Application of Jared Samples to amend the character area from CRC (Commercial Redevelopment Corridor) to the NC (Neighborhood Center) character area to allow residential development, at 5561-5567 Memorial Drive.

PETITION NO: D6-2026-1099 LP-26-1248188

LOCATION: 5561-5567 Memorial Drive, Stone Mountain, GA 30083

STAFF ANALYSIS

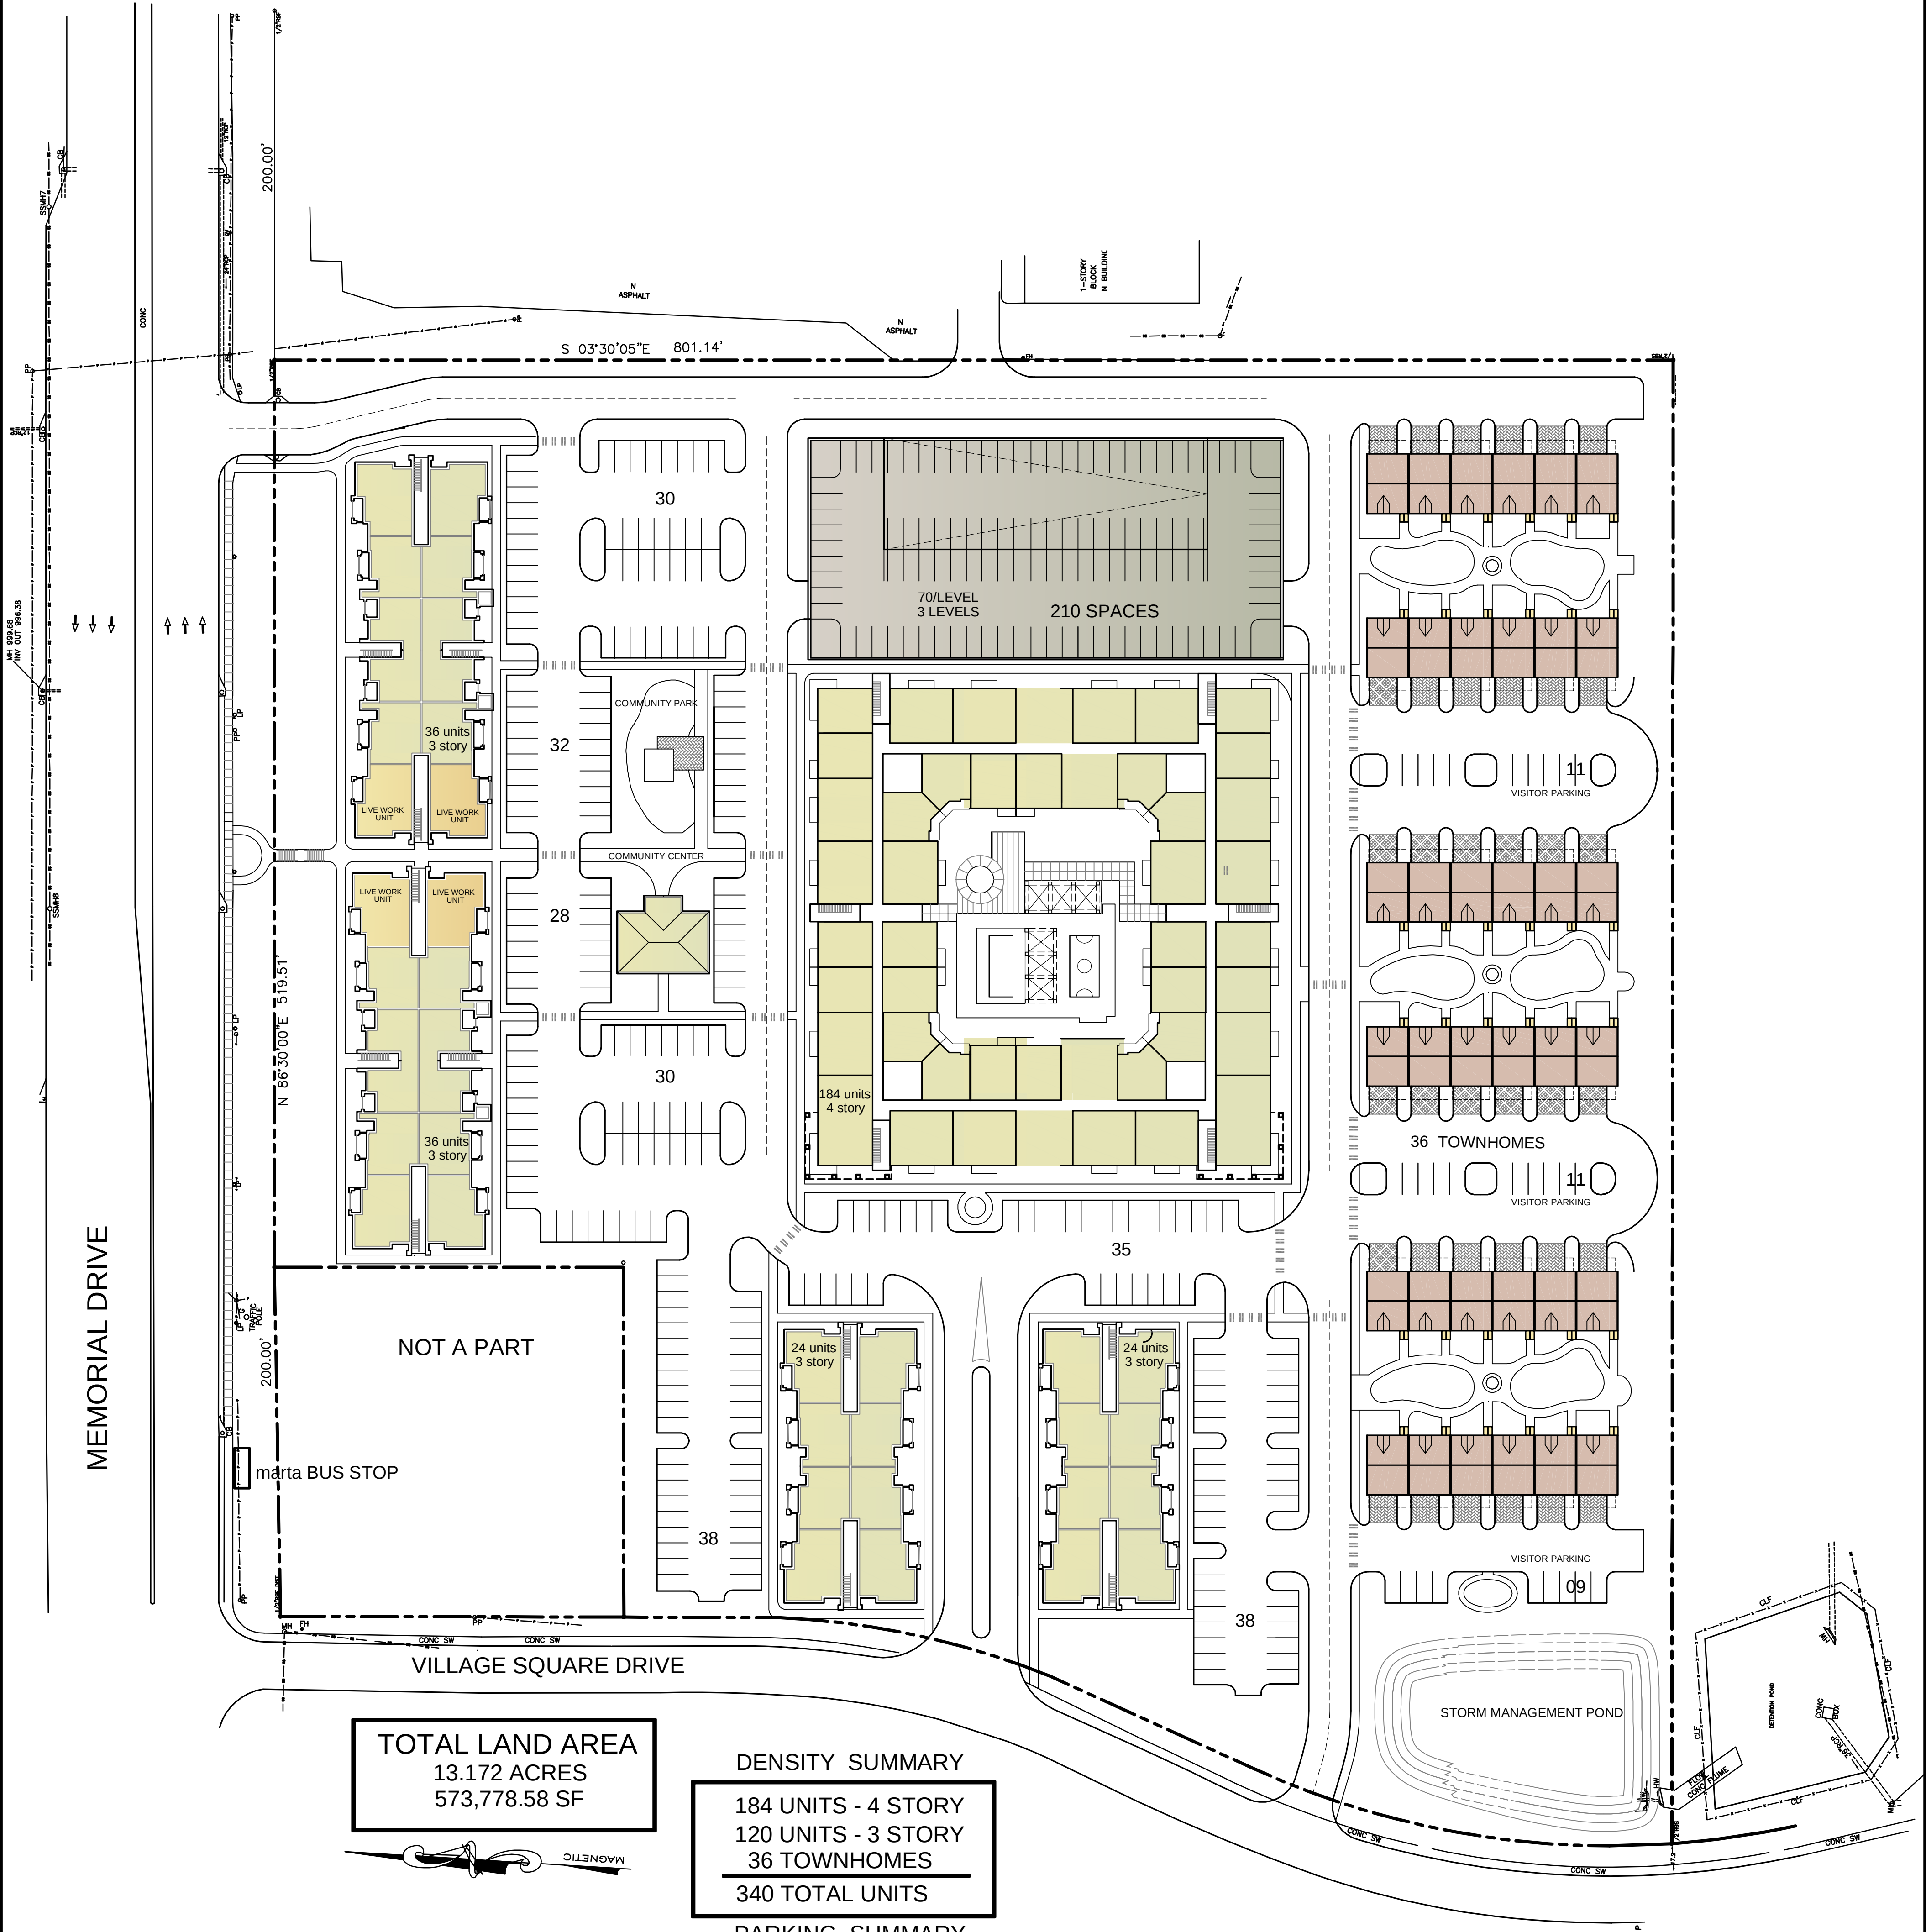
Staff contacted the Applicant on 8/4/26 with site orientation considerations to better achieve the overall NC vision. While the feedback is not intended to represent a required layout, but rather to demonstrate potential design opportunities that may be worth considering as the project evolves. The applicant revised and submitted an updated site plan on 8/11/26.

However, that concept increases the proposed residential density, still contained a large amount of surface parking, and remains entirely residential. As of 10/12/26, the Applicant has revised their plans regarding number of units, addition of pedestrian connectivity, activation of the site and transition around surrounding properties and parking. The site plan has improved based on last staff report feedback. This report will give an overview of such changes.

The subject property is currently designated as CRC, which the *2050 Unified Plan* intends for guiding redevelopment along commercial corridors, supported by more detailed Small Area Plans. However, the proposed redevelopment does not fully reflect CRC recommendations. The Memorial Drive Revitalization Plan SAP, which includes the subject property, recommends a Neighborhood Center (NC) designation instead, reflecting community preferences to maintain small-scale retail character while introducing community-oriented amenities such as senior housing, park space, a library, and a small theater. The *2050 Unified Plan*'s NC Character Area supports activating spaces with neighborhood commercial uses, offices, mid-density housing, and public open space in a walkable environment, with residential density not exceeding 40 units per acre. The proposed development aligns with these objectives by incorporating live-work units and achieving a density of 26 units per acre.

The proposed site plan provides appropriate transitions between building types, concentrating apartments at the activity center's core and limiting building height near surrounding lower-intensity areas, consistent with NC Character Area Connectivity to a nearby bus stop and a stronger relationship with Memorial Drive enhance multi-modal access, while live-work units support local activity and align with the Plan's mixed-use goals. Additional pedestrian improvements, particularly along Village Square Drive, remain encouraged. The applicant further advances NC objectives by reducing parking in line with staff recommendations and improving site activation within Hambrick Village—an area currently defined by underutilized parking and limited tree cover. The requested FLUM amendment from CRC to NC is consistent with the SAP, and overall, the redevelopment better aligns the site with the pedestrian-oriented and community-focused goals of the *2050 Unified Plan*.
